**From:** Ed Swiatek  
**Sent:** Thursday, March 10, 2022 10:22 AM  
**To:** (b) (6); Stefan; Abigail Low - 3PX; Brett Molash - 3PCN; (b) (6)  
(b) (6)  
**Cc:** Gary Zimmerman - Zimmerman (3PCMB); Nathan Irwin  
**Subject:** RE: Harrisburg CH Toilet Partitions  
**Attachments:** DOC031022-03102022101129.pdf

**Subject:** Fwd: Harrisburg CH Toilet Partitions

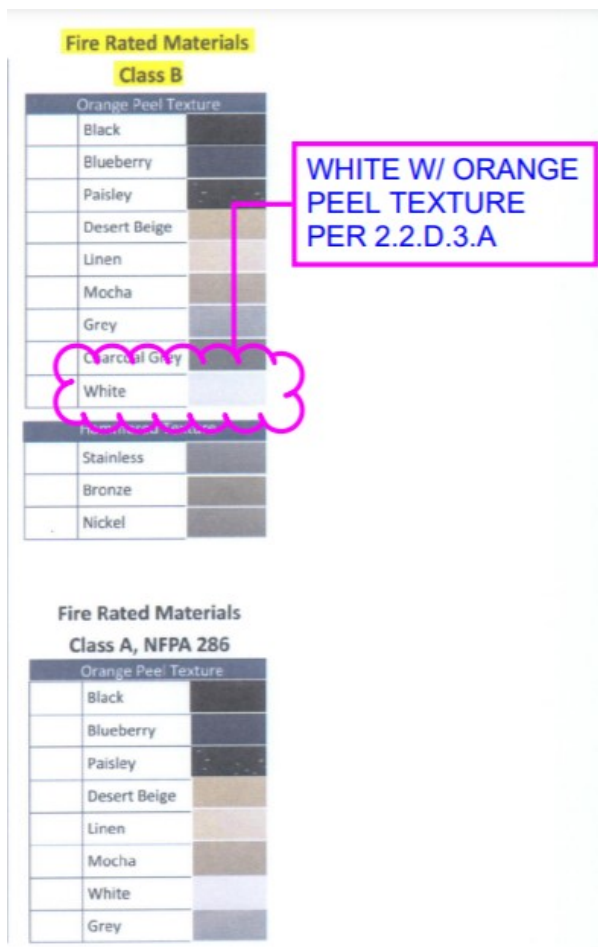
Yes, this looks like a problem since its HDPE and indicated here below in the last snip as **Class B without mention of passing NFPA 286.**

But the manufacturer does have white available where it does mention NFPA 286

**803.9 High-density polyethylene (HDPE) and polypropylene (PP).**

Where high-density polyethylene or polypropylene is used as an interior finish it shall comply with Section 803.1.2.
